Title - Sujet Fire Alarm Upgrade, Prince Albert, Fire Alarm Upgrade, Prince Albert, Saskatchewan	
Solicitation No. - N° de l'invitation EV385-220747/A	Amendment No. - N° modif. 006
Client Reference No. - N° de référence du client CSC EV385-220747	Date 2021-10-09
GETS Reference No. - N° de référence de SEAG PW-\$PWU-183-12154	
File No. - N° de dossier PWU-1-44068 (183)	CCC No./N° CCC - FMS No./N° VME
Solicitation Closes - L'invitation prend fin at - à 02:00 PM Mountain Daylight Saving Time MDT on - le 2021-10-26 Heure Avancée des Rocheuses HAR	
F.O.B. - F.A.B.	
Plant-Usine: <input type="checkbox"/> Destination: <input type="checkbox"/> Other-Autre: <input type="checkbox"/>	
Address Enquiries to: - Adresser toutes questions à: Ho (RPC), Hector	Buyer Id - Id de l'acheteur pwu183
Telephone No. - N° de téléphone (780) 901-0989 ()	FAX No. - N° de FAX (418) 566-6167
Destination - of Goods, Services, and Construction: Destination - des biens, services et construction:

Project No.: 079411.001

ADDENDUM No. 3

Drawing E3-6-1 (Detail 1)

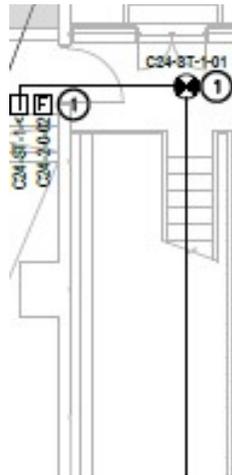
Please confirm 2 additional Isolation Modules are required.

Answer: 4 isolation modules to be provided for stairwells with more than one initiating/monitoring devices within the stair well.

Drawing E5-2-1 (Detail 1)

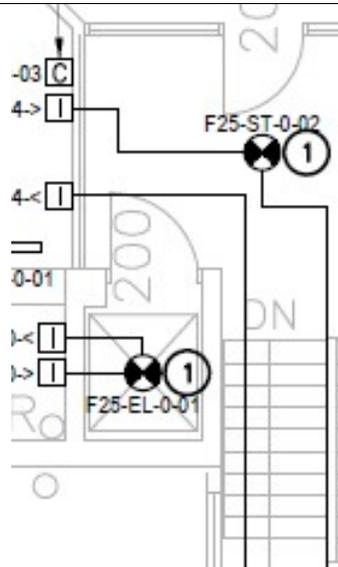
Please confirm 2 additional Isolation Modules are required.
